Village of Arlington Heights
Plan Commission
Board Room
Arlington Heights Village Hall
33 S. Arlington Heights Road
Arlington Heights, IL 60005
September 13, 2017
7:30 PM

VILLAGE OF ARLINGTON HEIGHTS **STAFF DEVELOPMENT** **COMMITTEE REPORT**

PC Project Number: PC 16-012
Project Title: Ivy Hotel
Address: 519 W. Algonquin Rd.
PIN: 08-16-103-008, 08-16-103-009

VILLAGE OF ARLINGTON HEIGHTS STAFF DEVELOPMENT COMMITTEE REPORT

1 PROPOSED SITE PLAN
SCALE : 1" = 20'-0" AUGUST 8, 2017 NORTH

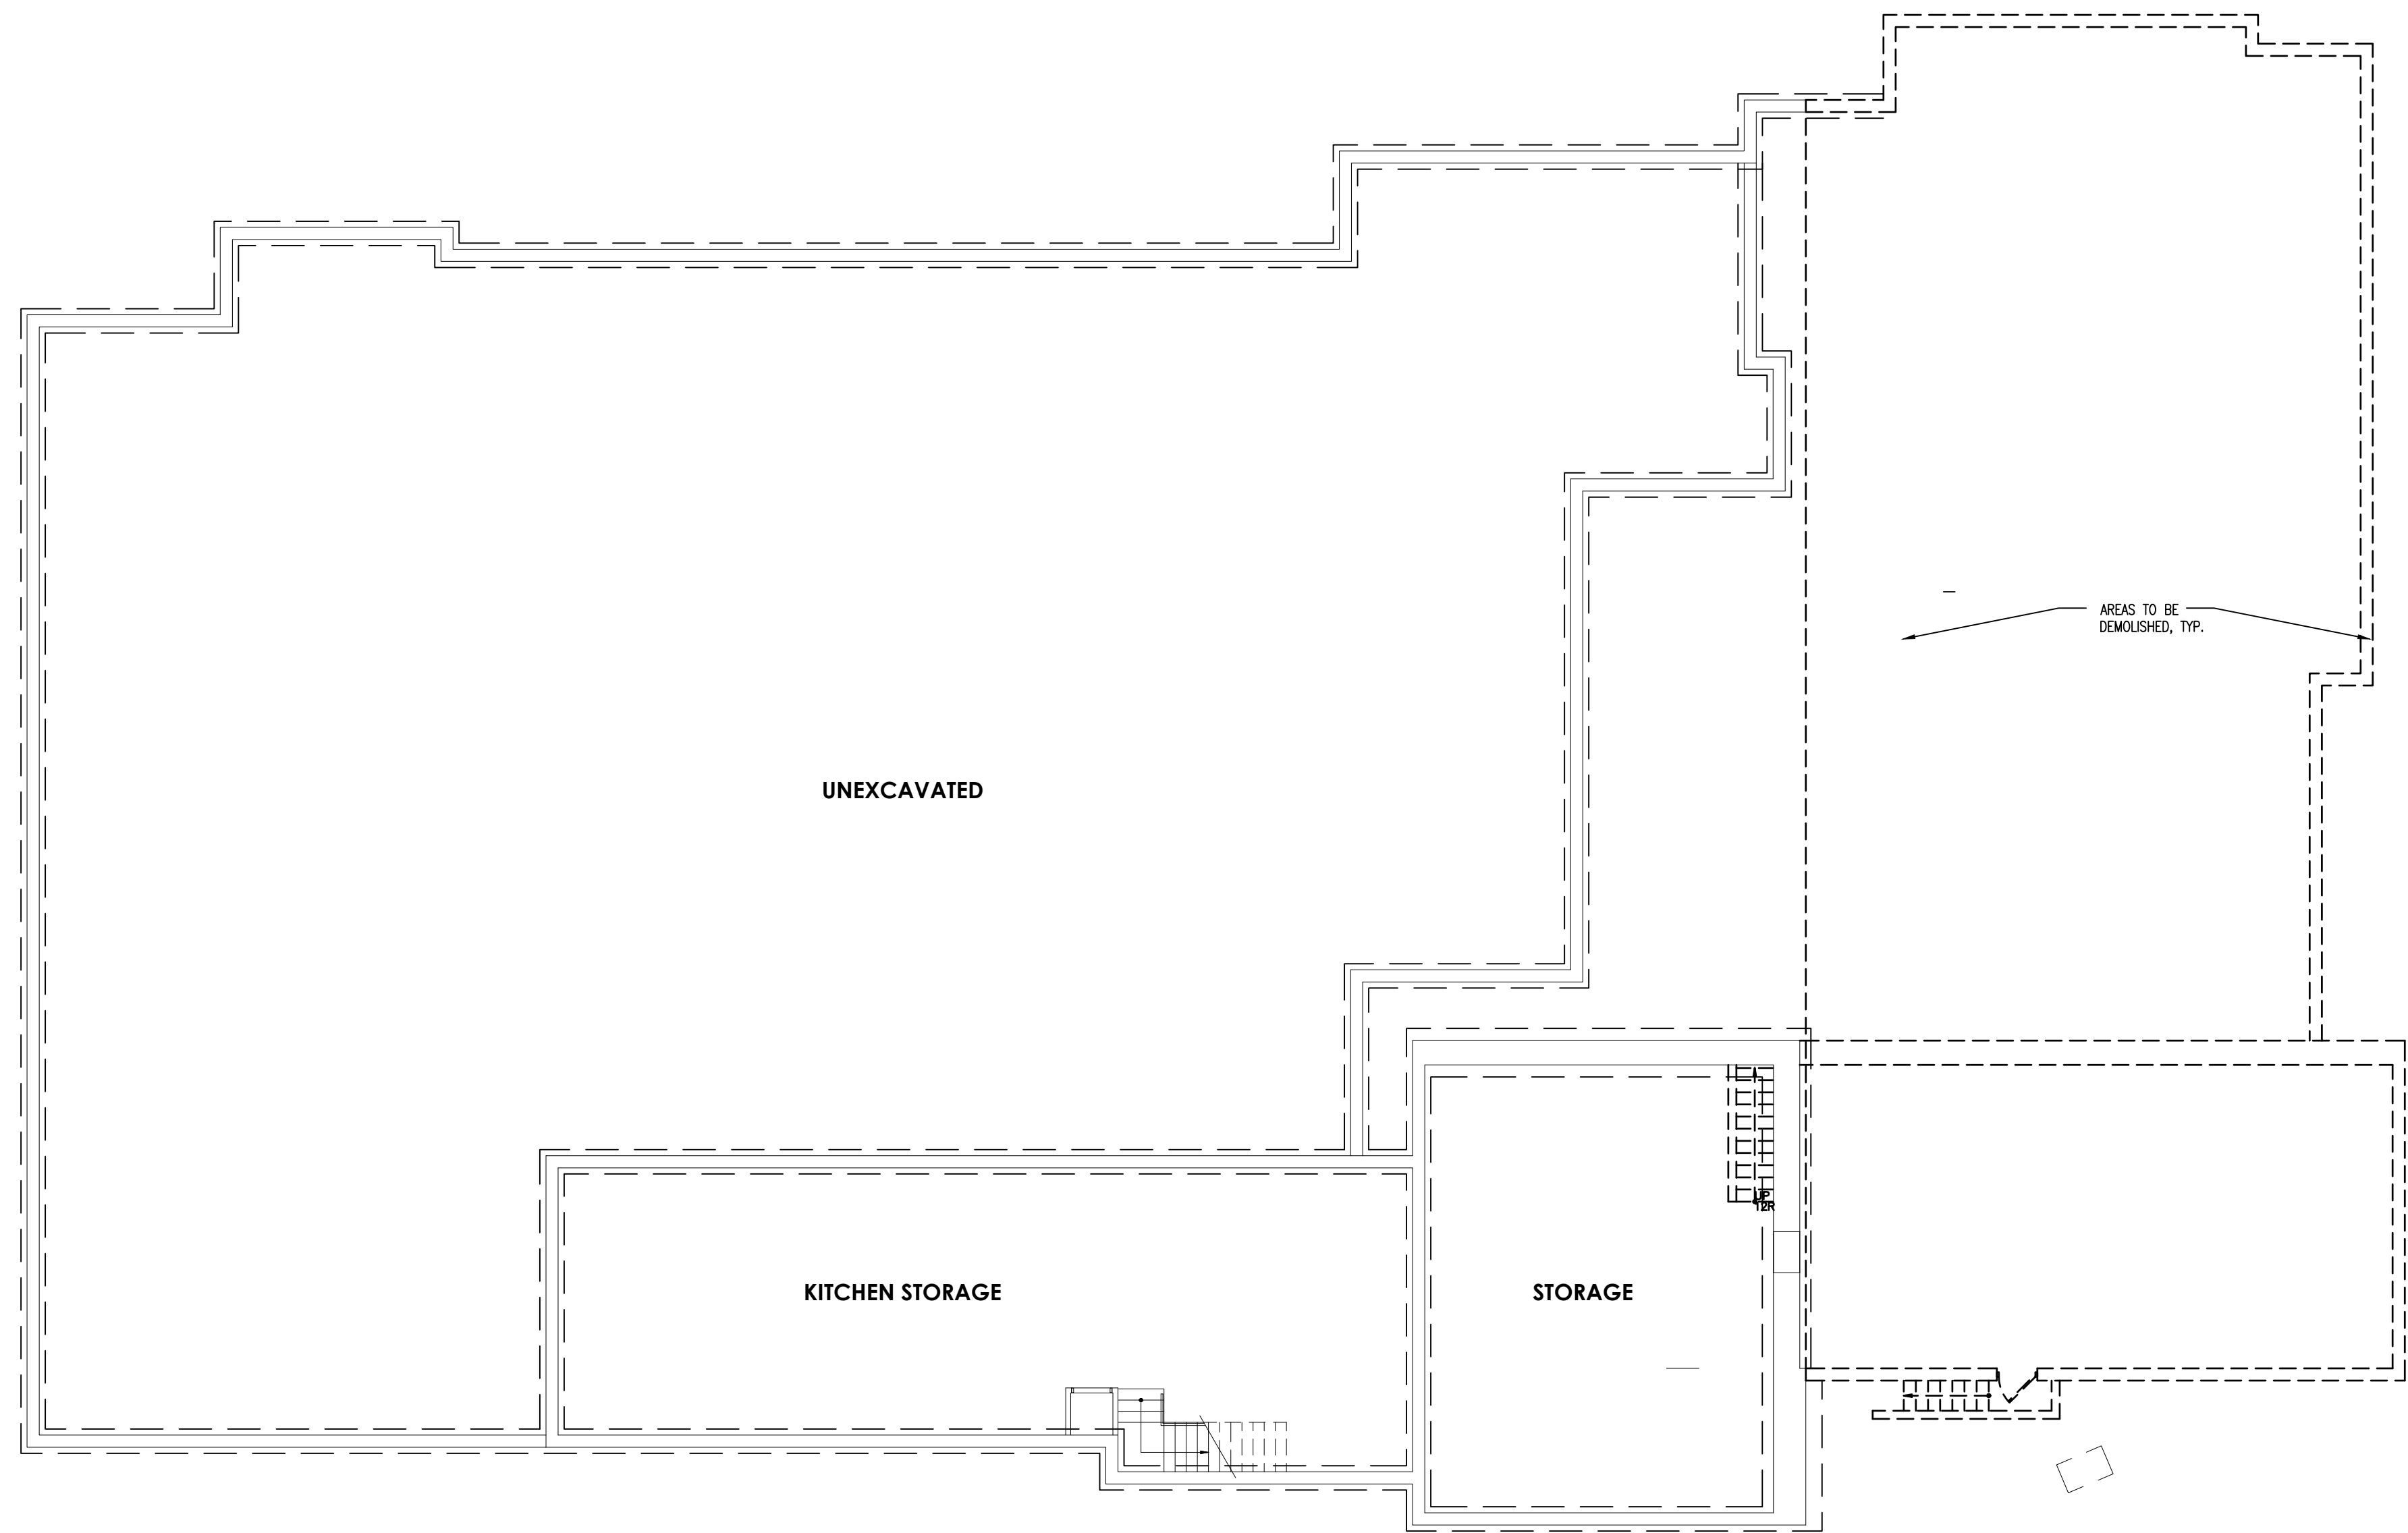
8. Many of the plan sheets are still inconsistent. Specifically:
 - a. The Site Plan (sheet A-0) does not show the new curb and sod area along the western side of the building.

25. The Site Plan (sheet A-0) indicates that there are a total of 150 parking spaces proposed on the site as a result of the Ivy Hotel development. However, 152 spaces are shown on the plan. Additionally, the Site Plan indicates that 25 valet spaces will be provided, however, 27 valet spaces are shown on the plan. Please revise the plan to reflect the actual number of proposed parking spaces and valet spaces. Additionally, please consider that the Ordinance #00-012, which granted the Special Use Permit for the banquet facility, limits valet parking to only the "plan east and west" circulation aisles.

Preliminary Utility & Site Plan

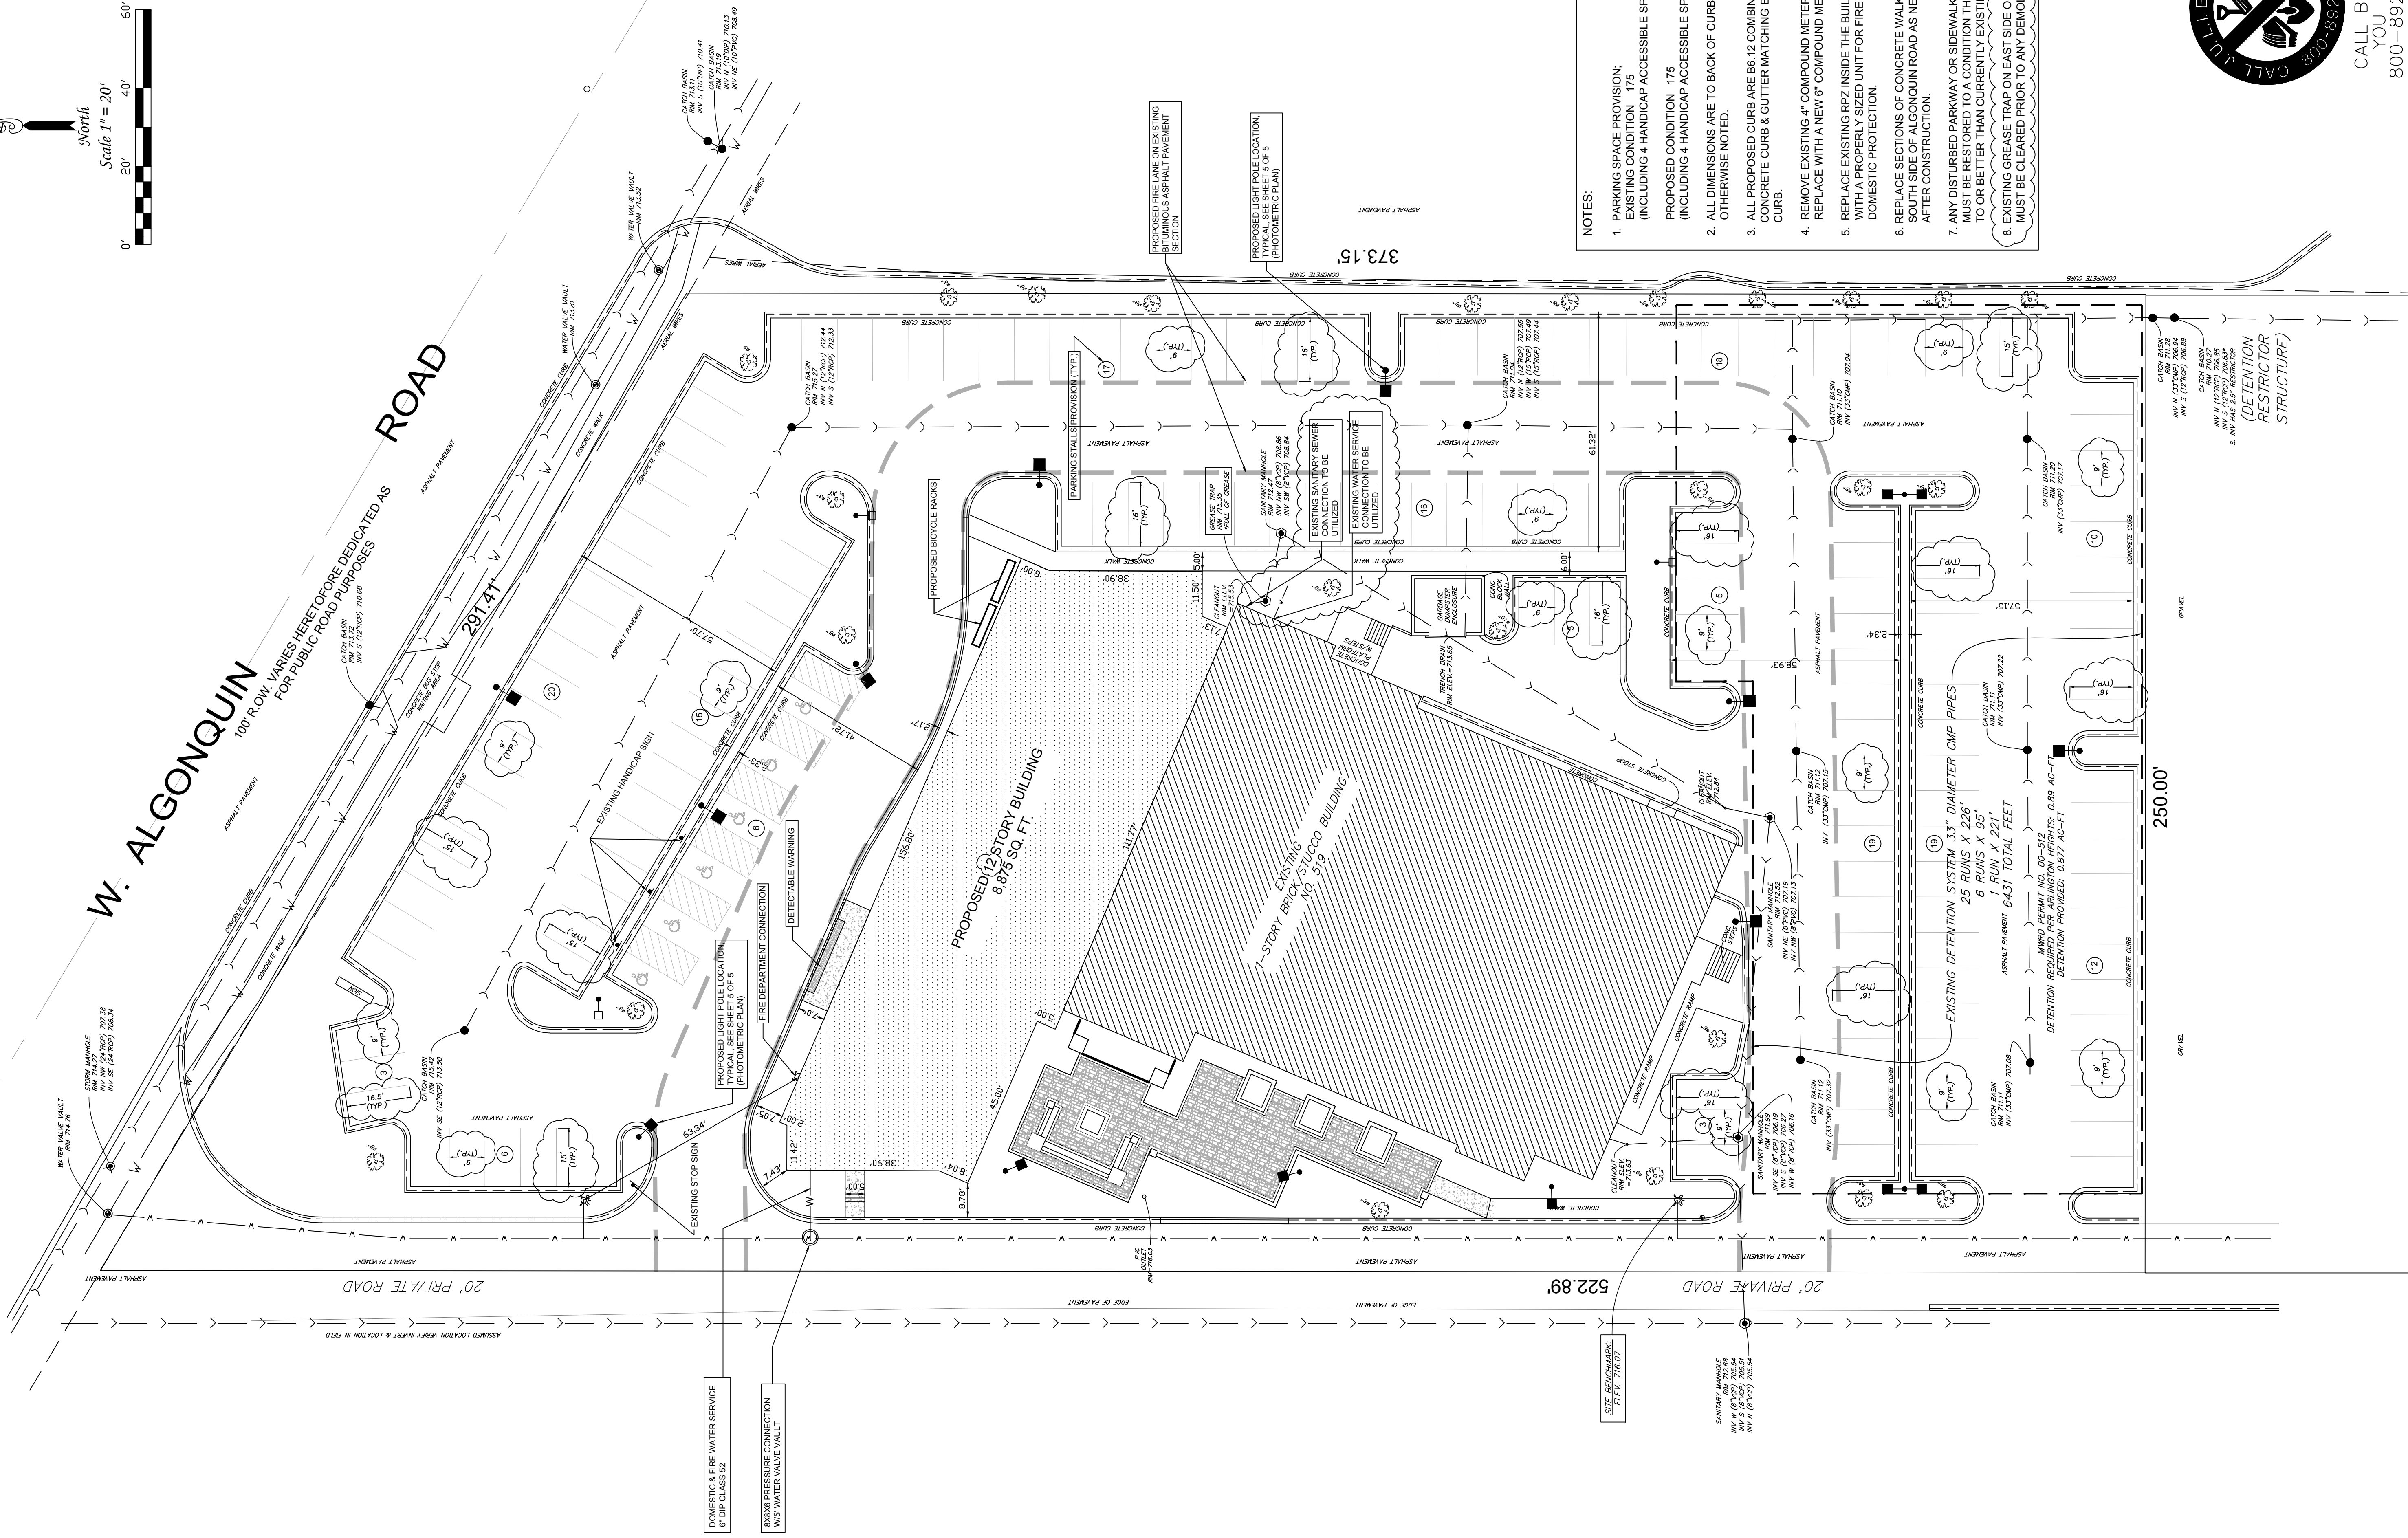
- 1) What is the purpose of the proposed 6" pressure connection and new fire and domestic water line into the proposed new building (Ridgeline Consultants drawing 3 of 5)? This is a new water service.
- 2) After the new fire and domestic service is installed, the old "original" service to the banquet hall needs to be abandoned and reconnected to the new service. **One service for one customer.**
- 3) A new 6" compound meter is required.
- 4) The new RPZ's for domestic and fire protection will be sized once flow calculations by the designer have been completed.

Truck Turning Exhibit

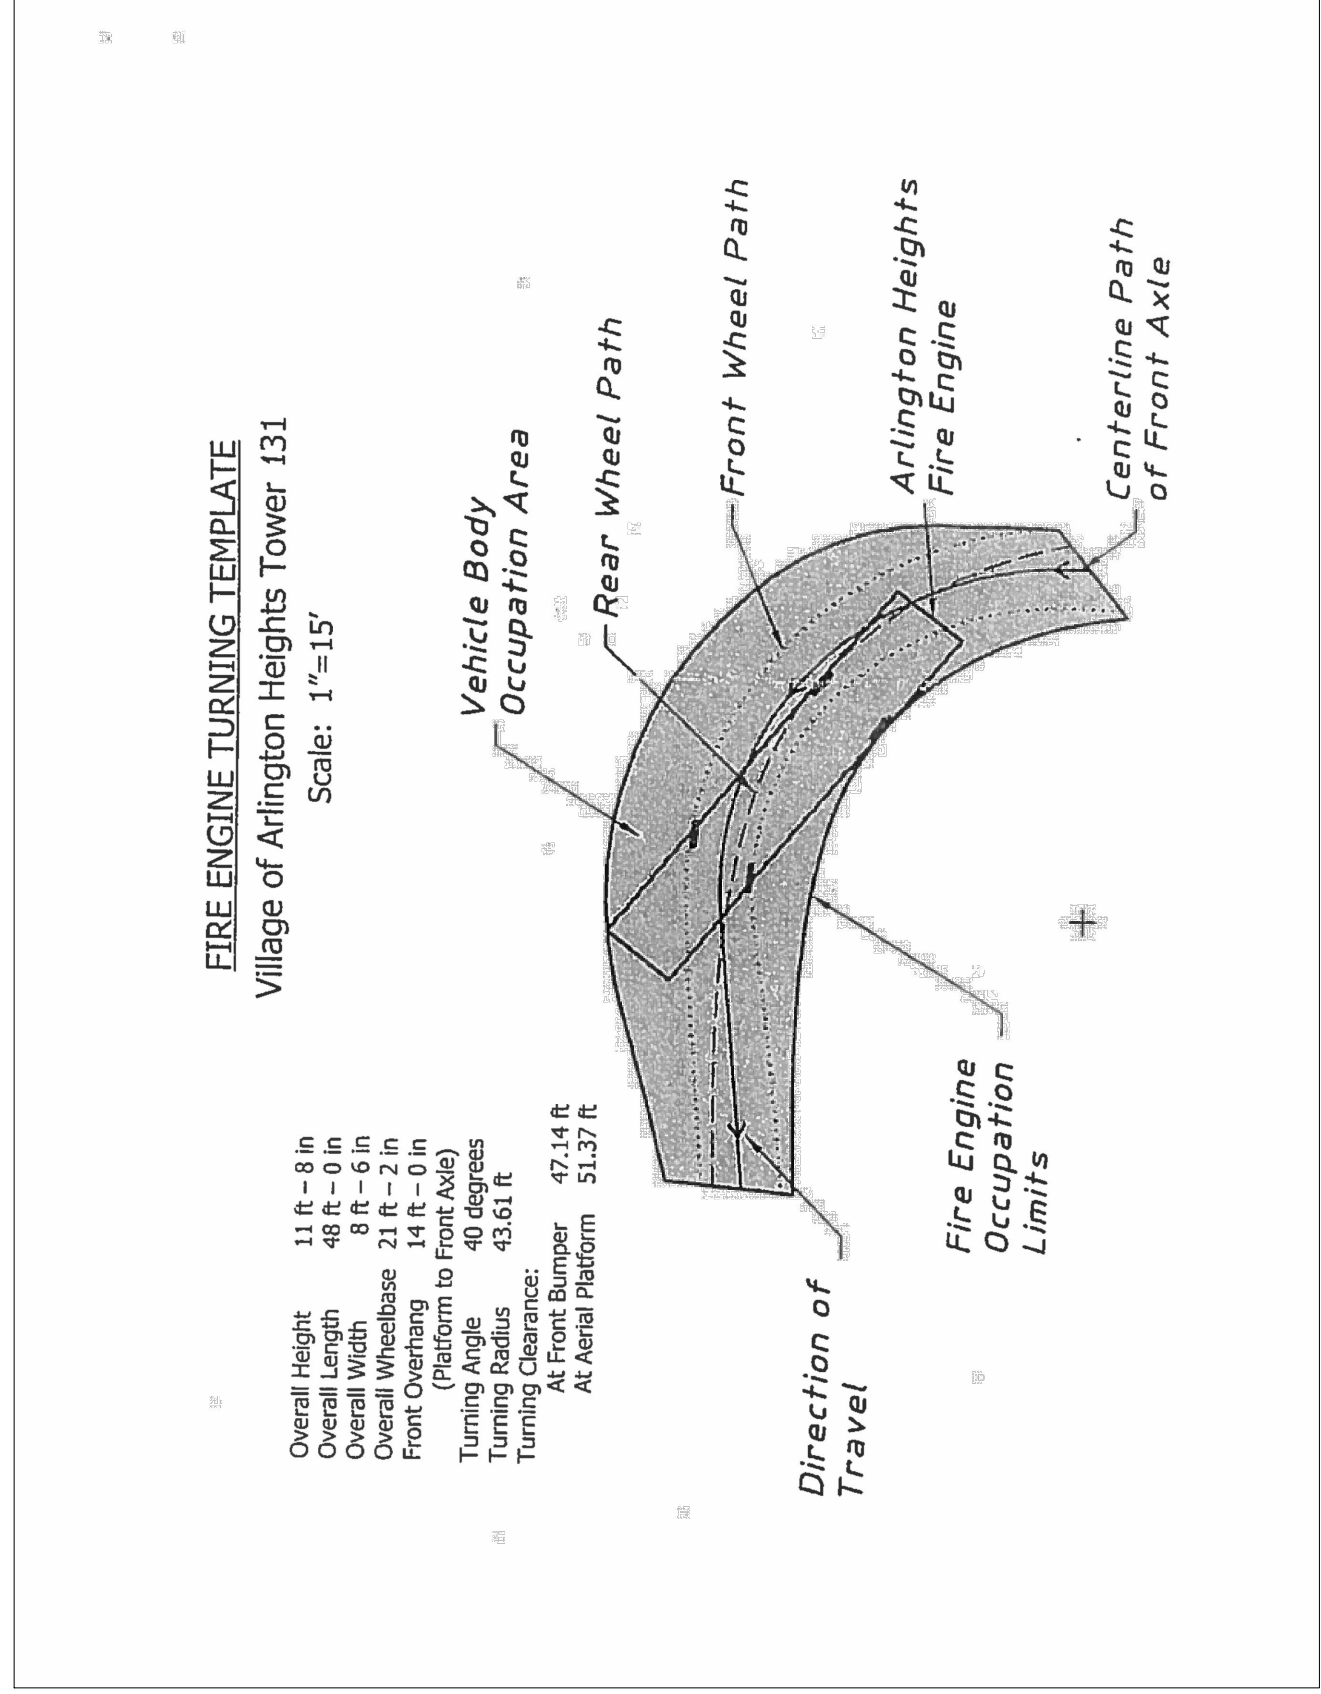
15. Any under pavement stormwater facilities must be designed to handle AASHTO HS-25 loading.
16. The exhibit on Sheet 6 showing the responding vehicle turning path labels the truck as "Itasca Fire Truck 2". Use the enclosed attachment for the Village of Arlington Heights's responding vehicle.
